**Swanmore Road
Havant
PO9**

**PROPOSED SITE ACCESS, INFORMAL CROSSINGS & INTERNAL
LAYOUT**

STAGE 1 ROAD SAFETY AUDIT

Report No. EC/2022/04/GTA2

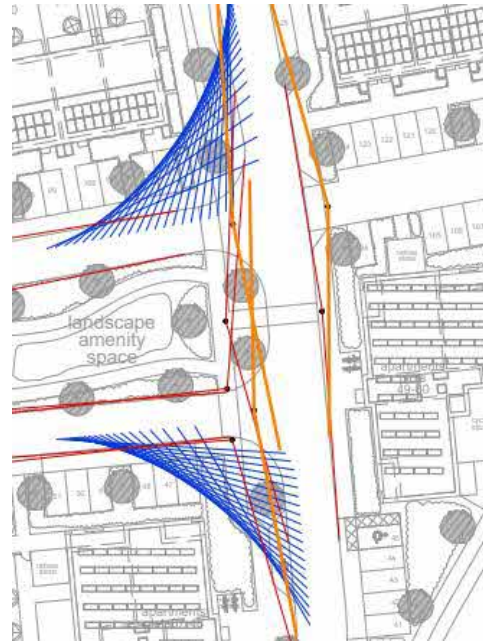
3.3.1 PROBLEM

Location: Various junctions within the proposed development

Summary: Risk of failure to give way type collisions and side swipe collisions.

A visibility splay plan has been provided to the Audit Team that shows the forward visibility and general sightlines at each junction. Whilst it would be expected vehicle speeds would be low within the development, drivers will be required to give way on the approach to each junction with the 'main' through road or 'spine' road running through the development. However, the plan indicates new trees and planting close to the junctions. It is unclear at this stage the size of the proposed trees and the type. Many of the sightlines appear to be obstructed by such trees and as such could result in drivers failing to give way to oncoming vehicles. This could risk side swipe collisions occurring.

Trees removed from sightlines to always ensure good and unobstructed visibility.
